ADDENDUM TO JANDY CXI

Addresses Commonwealth of Massachusetts Requirements for Manual Reset High and Low Gas Pressure Switches FOR CXi MODELS: 500, 650, & 750

Figure A - 500,000 to 750,000 BTU Models

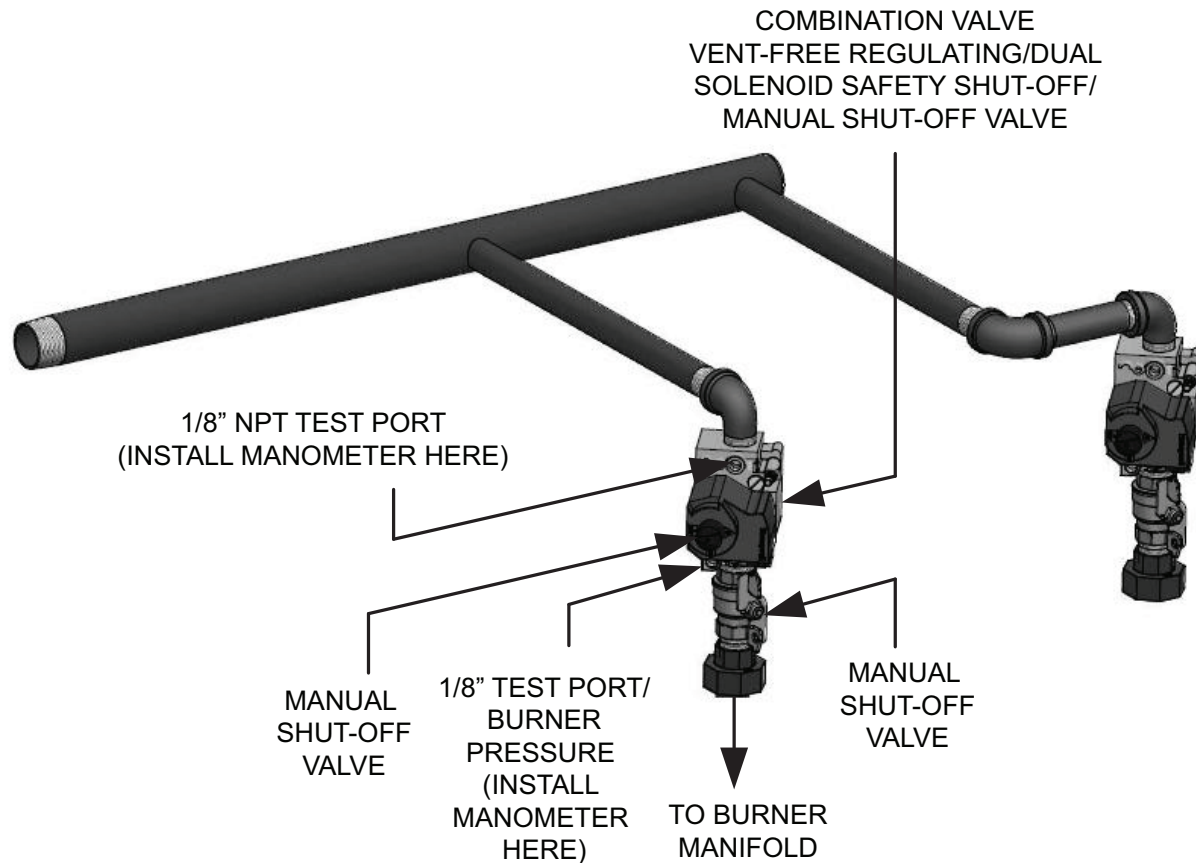
In the Commonwealth of Massachusetts, gas appliances over 1,000,000 BTU must be equipped with manual reset high and low gas pressure switches.

The following models may be equipped from the factory with high and low gas pressure switches when required to meet the Massachusetts requirements.
